NON - MATERIAL AMENDMENT

Mr ands Mrs Woodhouse / Hunter Whalley Lancashire Existing and Proposed Plans and Elevations

2292-01

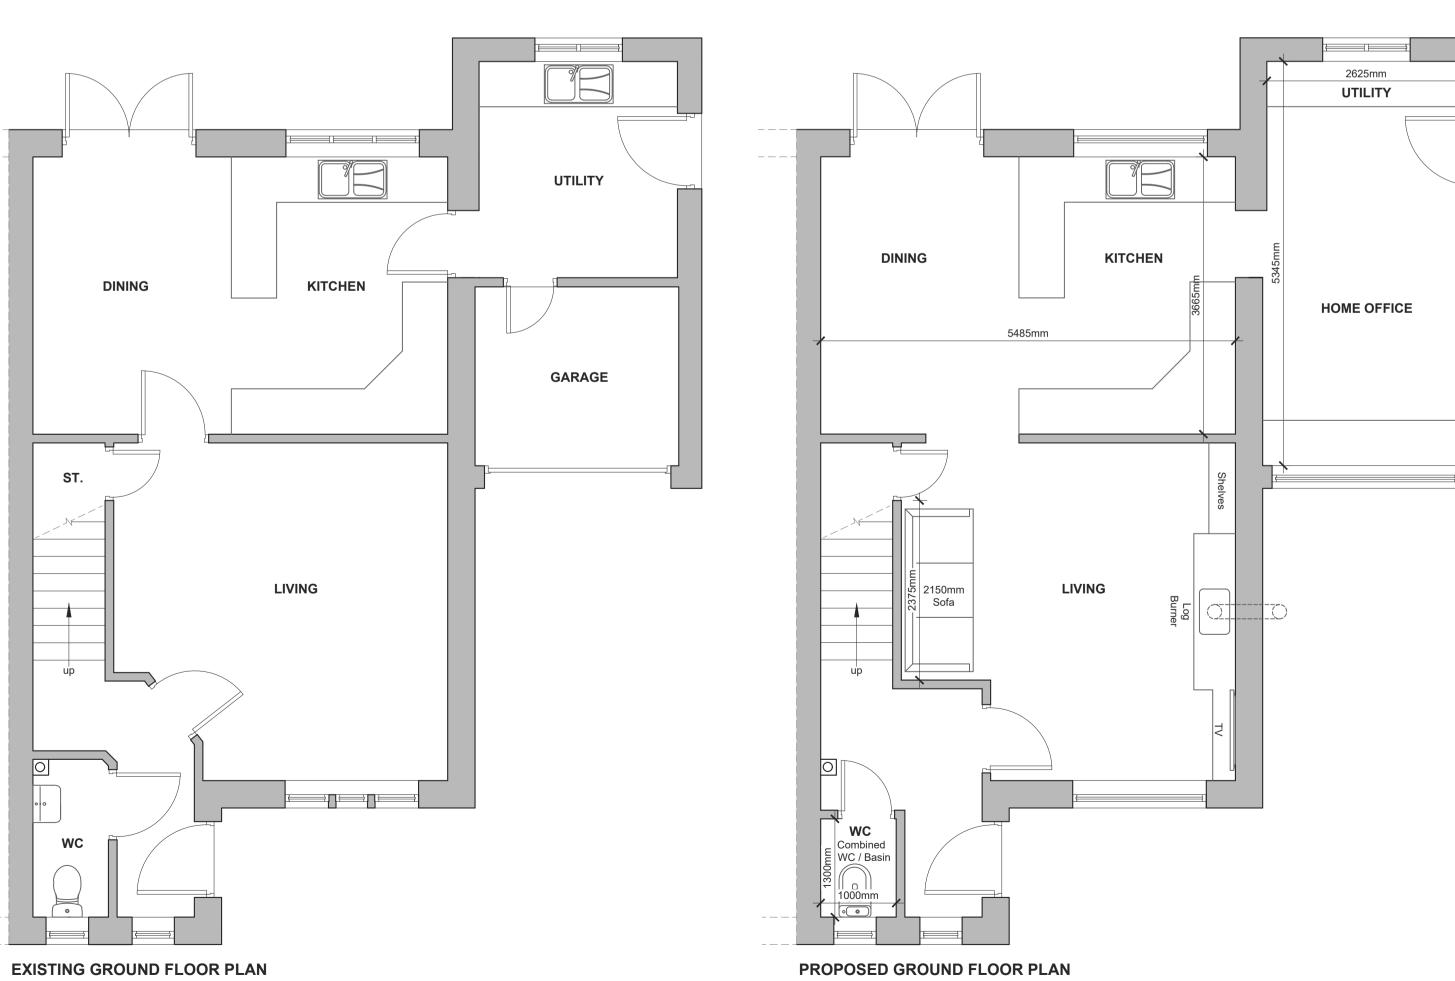
- 1/. Proposed French doors to the North West Elevation omitted from design Existing window to be replaced with a single pane unit
- 2/. Existing window in South East Elevation to be replaced with a single pane unit
- 3/. Window to replace Garage door to be altered to a single pane unit
- 4/. Stone infill below window to replace garage door to be omitted and replaced with blockwork with a white rendered finish.
